Montgomery County Historic Preservation

Staff Report

<p>ADDRESS: 7818 Overhill Rd., Bethesda</p> <p>RESOURCE: Greenwich Forest Historic District</p> <p>APPLICANT: Bill and Allison Trunk</p> <p>REVIEW: HAWP</p> <p>CASE NO.: 1155067</p> <p>PROPOSAL: Accessory Structure Alterations</p>	<p>MEETING DATE: 5/13/2026</p> <p>REPORT DATE: 5/6/2026</p> <p>PUBLIC NOTICE: 4/29/2026</p> <p>TAX CREDIT ELIGIBLE: No</p> <p>STAFF: Dan Bruechert</p>
--	---

TRUNK GARAGE RENOVATION

3 PROPOSED GARAGE ELEVATIONS
Scale: 1/4" = 1'-0"

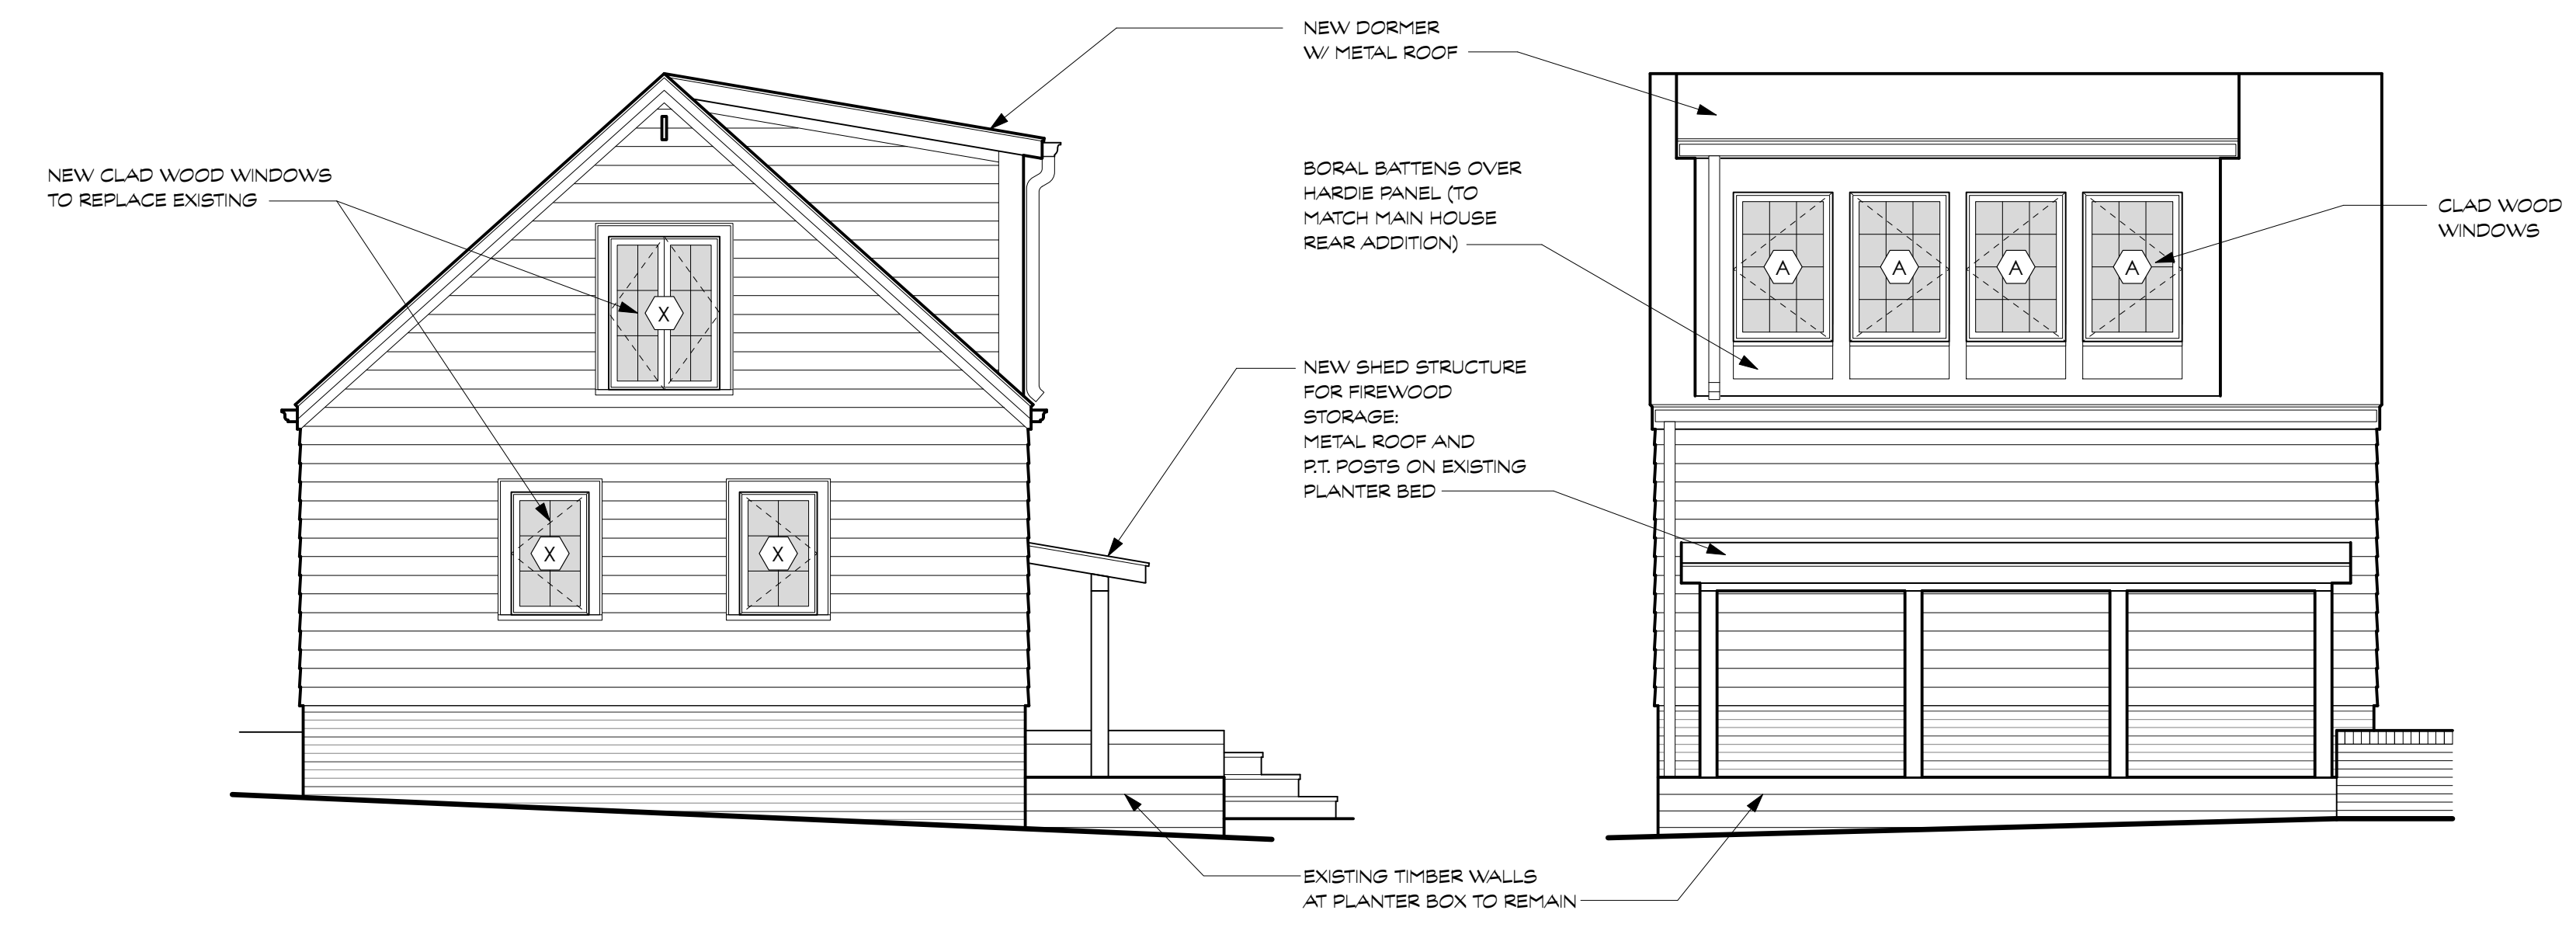
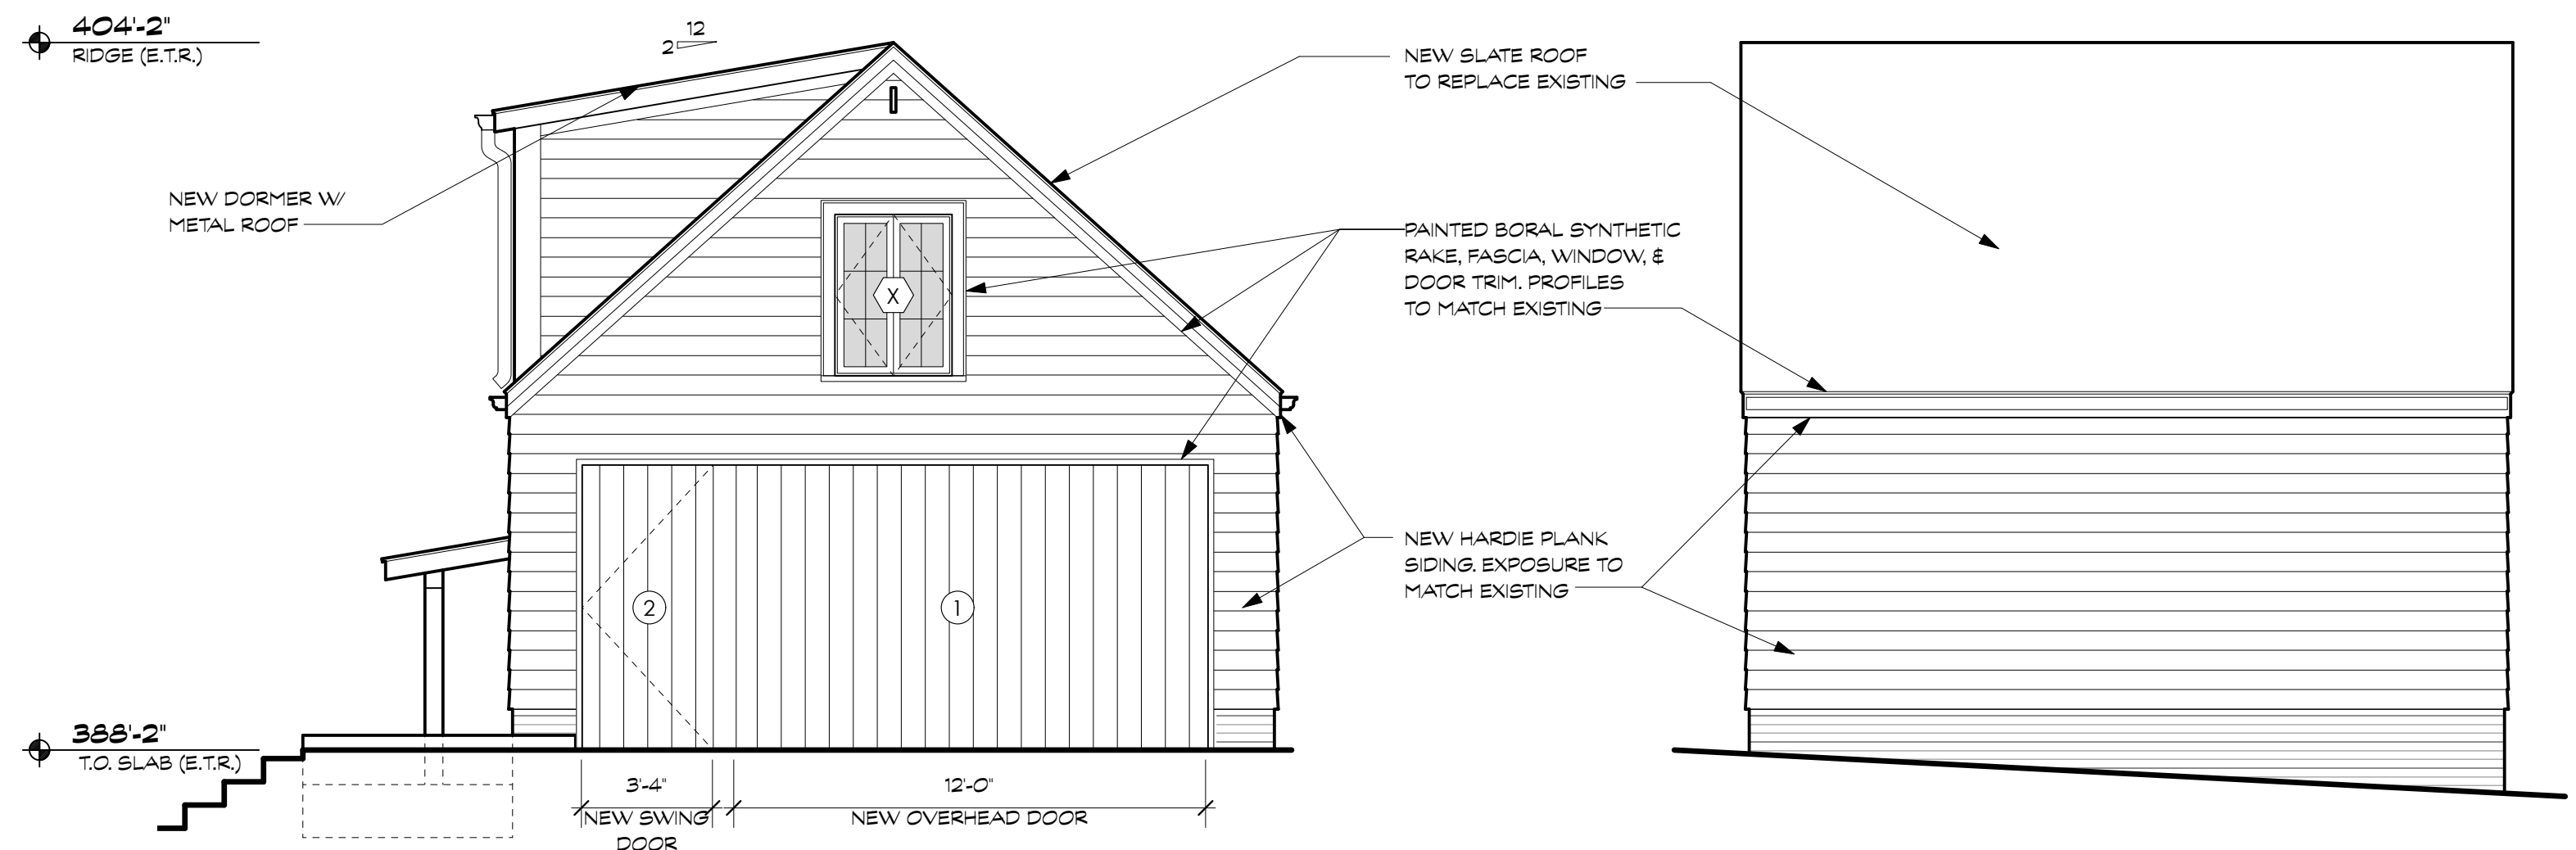
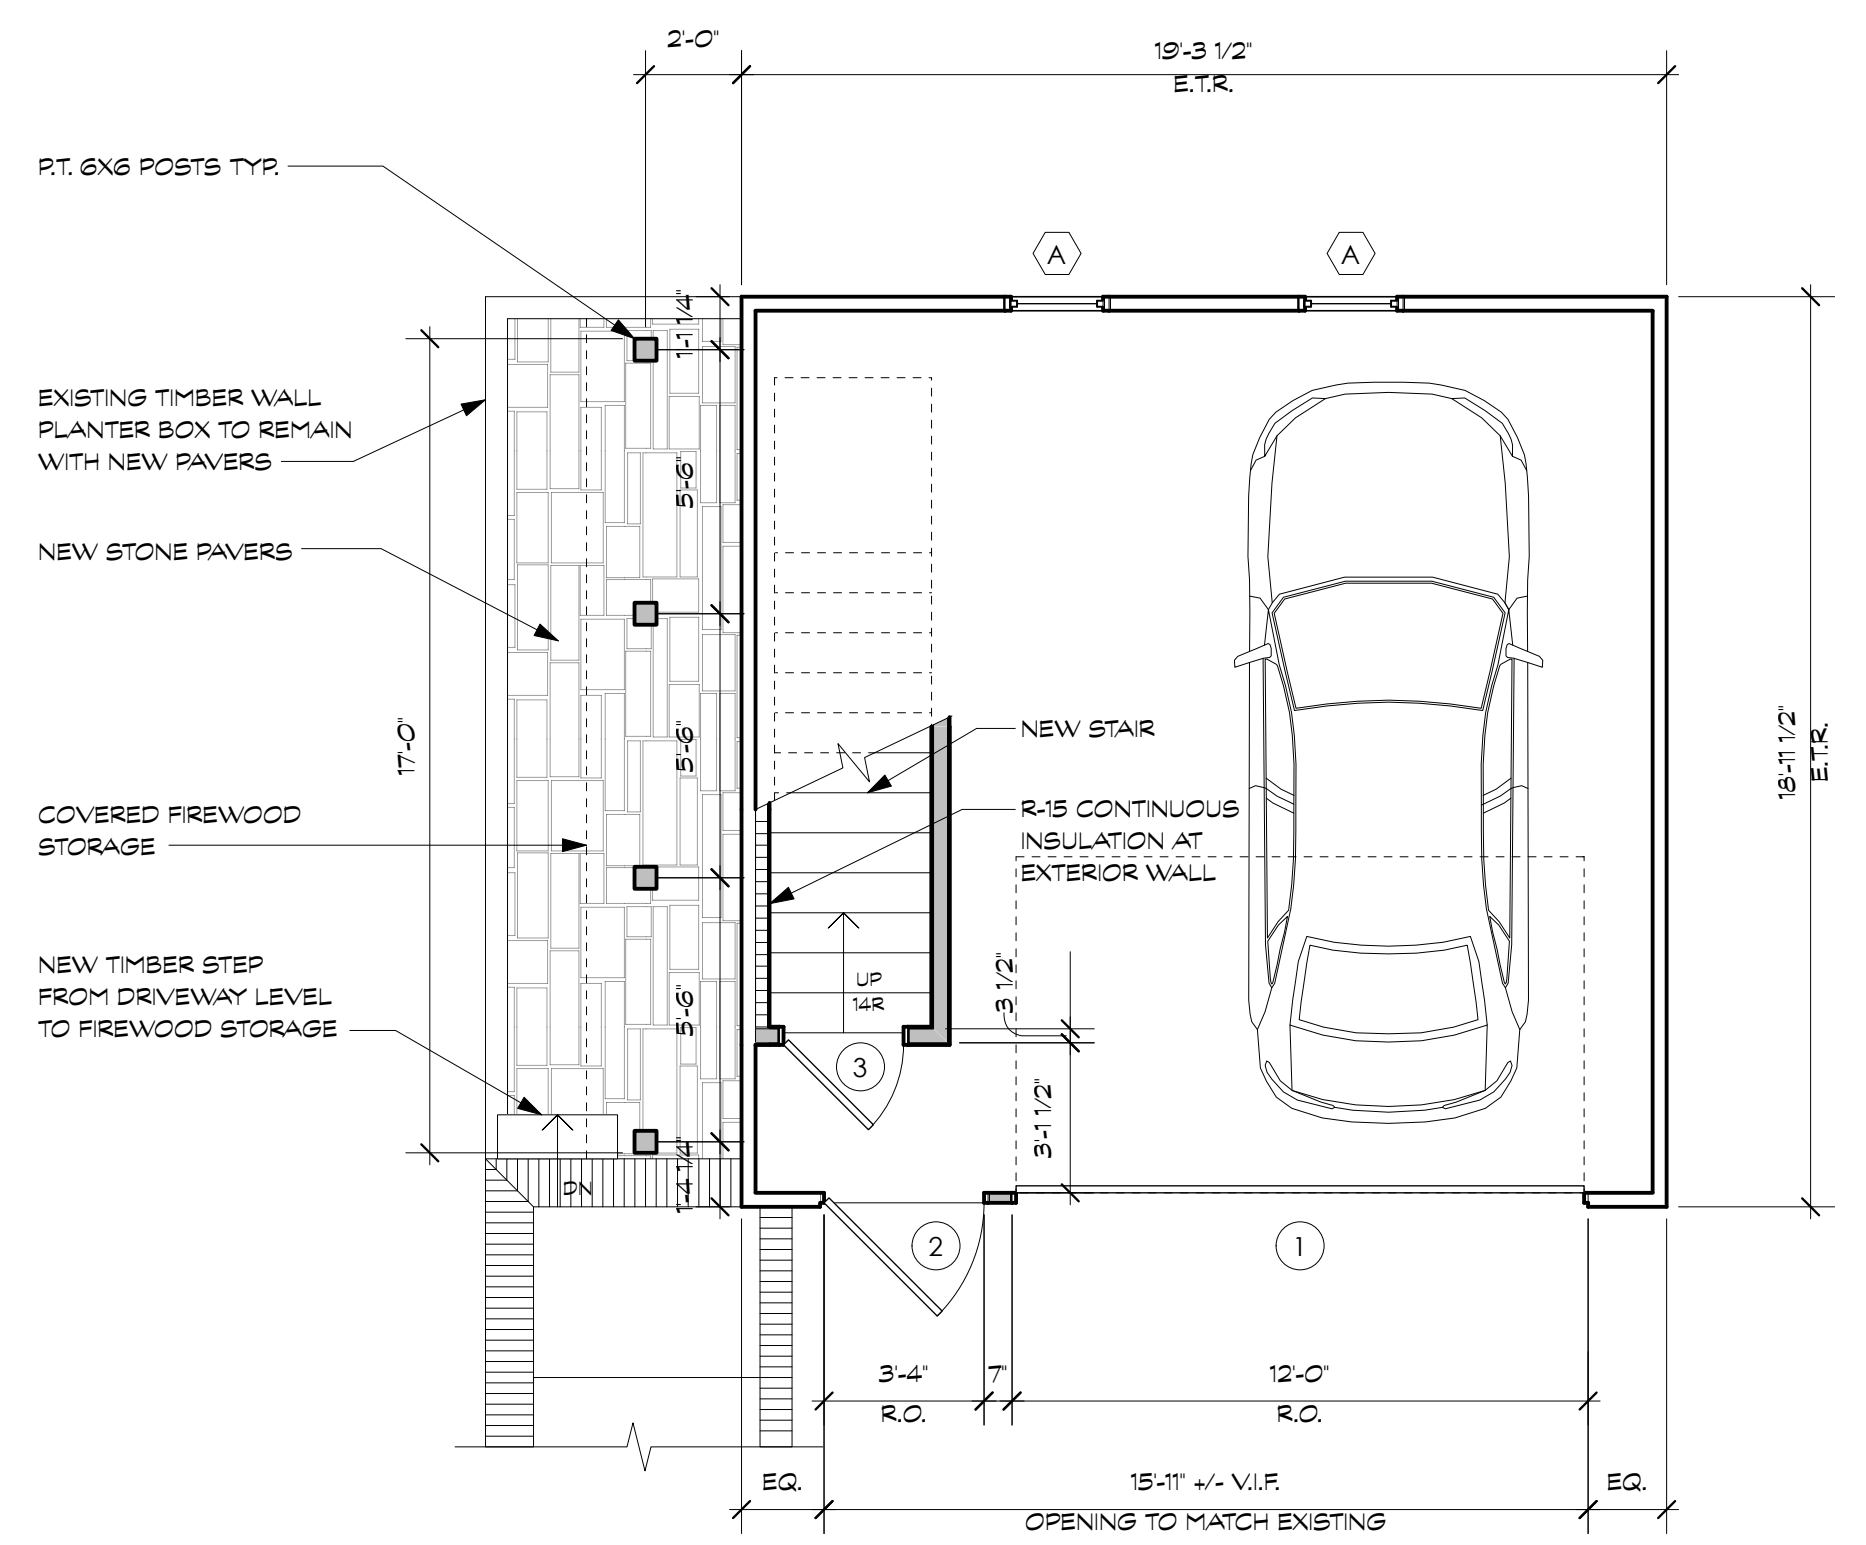
The applicant proposes to construct a shed dormer on the left (south) roof slope of the garage. The dormer will be 13’ 5 ½” (thirteen feet, five and one-half inches) wide and is set back 4’ (four feet) from the front wall plane. The dormer’s roof slope is a low 2:12 and will have a metal roof. Siding and trim details on the front and rear elevations will match the new siding and trim, discussed above. On the left elevation, the applicant proposes to install fiber cement panel siding and four twelve-lite Weathershield Signature Series aluminum clad casement windows.

Staff finds the dormer will alter the massing of the garage, but will retain the outline of the original building, an identified objective of guideline D4; and does not raise the roof ridgeline as required in D17. Additionally, Staff finds the siding is identical to the fiber cement siding proposed to replace the deteriorated wood siding (discussed above), which will aid in making the design more cohesive. Finally, Staff finds the dormer’s proposed aluminum clad windows are appropriate for new window openings in the Greenwich Forest Historic District, as outlined in D17, as they have a traditional grille pattern and provide sufficient dimensional details to approximate the appearance of a wood window.

Staff finds the existing garage door may be the historic configuration, as the only access to the garage interior is through this door. The door appears to suffer from some deterioration, particularly where the door meets the driveway. The *Design Guidelines* provide a very lenient requirement for replacing windows and doors and do not require that they have deteriorated beyond repair as is the case in most of the county's historic districts. The primary consideration is that the windows and doors are consistent with the design of the house and that windows have permanently affixed exterior divisions. Staff finds the proposed replacement swing door satisfies these criteria. The front elevation of the proposed garage shows a replacement overhead door with vertically oriented boards, but no material or detailed specifications were included in the application materials. Staff recommends the HPC add a condition to the approval of this HAWP that requires detailed overhead door specifications be submitted to Staff before issuing the final HAWP approval documents. Final approval authority to ensure the door design and materials are appropriate under D17 can be delegated to Staff. With the recommended condition, Staff finds the proposed door replacements are consistent with the *Design Guidelines*, 24A-8(d), and *Standard #2*.

The garage has four window openings. There are a pair of wood casement windows under the gable on the front elevation. On the rear there are two wood six-lite casement windows on the ground floor and a paired set of casement windows under the gable. All of the windows appear to be historic. The applicant proposes to replace the existing windows with Weathershield Signature Series aluminum clad windows in matching dimensions and configurations.

Staff finds the proposed shed will not have a substantial impact on the character of the garage. Its simple, open design does not detract from the historic form of the garage. Staff additionally finds the proposed materials are compatible with the character of the garage. The metal roof matches the dormer roof and the wood framing and posts are traditional materials. A specification for the stone pavers was not provided and Staff recommends the HPC include a condition to the approval of this HAWP to require the applicant to submit a detailed specification for the pavers to Staff for review and approval before issuing the final approval documents. Final approval authority to ensure the material is appropriate can be delegated to Staff. With the recommended condition, Staff finds the shed roof construction is compatible with the character of the garage and the *Design Guidelines*, 24A-8(b)(2) and (d), and *Standard #2*.

Staff recommends the HPC approve with two (2) conditions the HAWP application with final approval delegated to staff:

1. A detailed specification for the overhead garage door must be submitted before issuing the final HAWP approval documents.
2. A detailed specification for the pavers under the shed roof must be submitted before issuing the final HAWP approval documents.
